Service Information No. 04 / 07**Date:** 15.03.2007**Turbocharger TPL 76C; Filter Silencer sheet metal ring 8/9 M 43C**

TPL76-C Filter Silencer

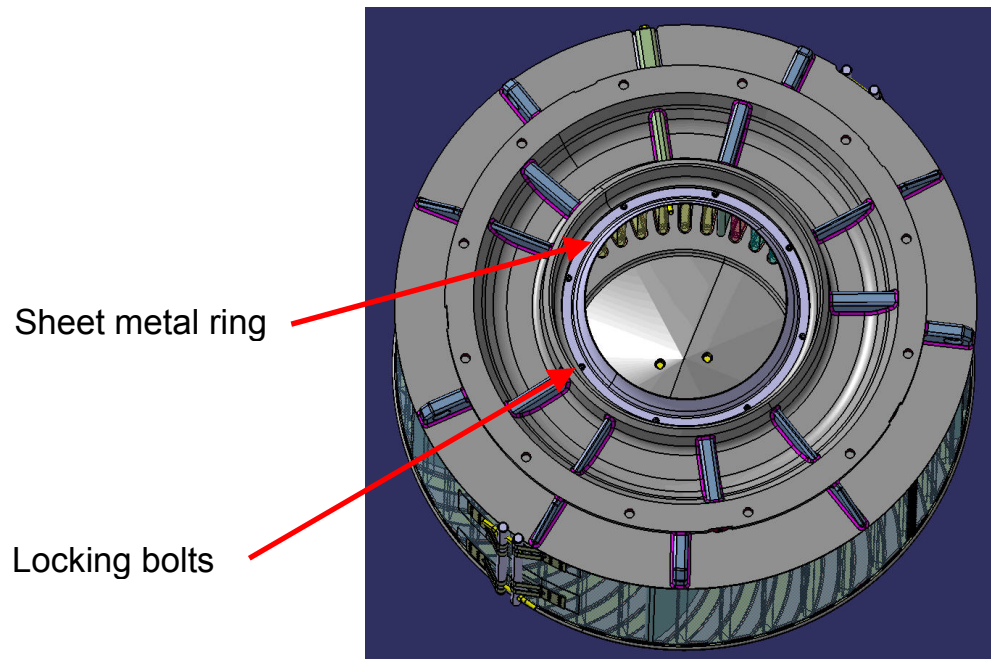
It has been decided to remove all sheet metal rings from the silencers in the field in order to prevent further failures due to cracks. First investigations have revealed that this measure will not affect the efficiency of the turbocharger. Further measurements on the test rig and CFD calculations are ongoing in order to confirm this theory.

The bonded sheet metal rings can easily be removed by means of a hammer. In case of the sheet metal ring was already locked in position by locking bolts, these bolts have to be removed first.
